UNITED STATES PATENT AND TRADEMARK OFFICE

APPLICATION NO.	FILING DATE	FIRST NAMED INVENTOR	ATTORNEY DOCKET NO.	CONFIRMATION NO.
10/664,490	09/17/2003	John F. Boylan	ACS 65471 (2133XXD)	4845

Office Action Summary	Application No. 10/664,490	Applicant(s) BOYLAN ET AL.	
	Examiner Michael G. Mendoza	Art Unit 3734

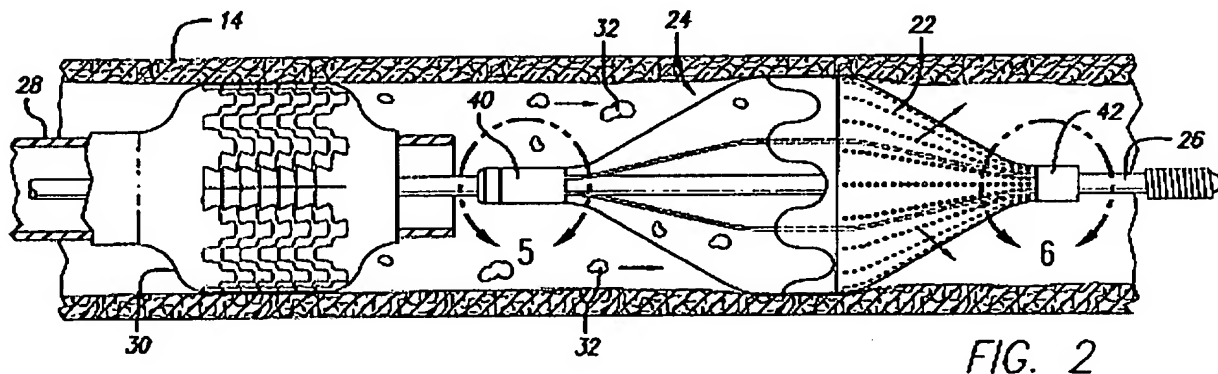
12. As to claims 32, 33, 38, 41, and 43, Huter et al. teaches an embolic protection device for capturing embolic debris released into the body vessel of a patient, comprising: a shaft member; a filtering element including an expandable strut assembly and a filter attached to the strut assembly; a layer of polymeric material deposited only

on portions of the strut assembly proximal to the filter; wherein the polymeric material is selected from the group consisting of PTFE and polyimide; and wherein the expandable strut assembly is made from a material having self-expanding properties (col. 6, lines 36-37).

13. Huter et al. teaches depositing a polymeric material only on the external surface of the strut (col. 7, lines 26-29). The filter is placed on the external surface of the strut. The external surface of the strut is more proximal to the filter than the internal surface of the strut. Therefore, Huter et al. teaches the limitation of only on portions of the strut assembly proximal to the filter.
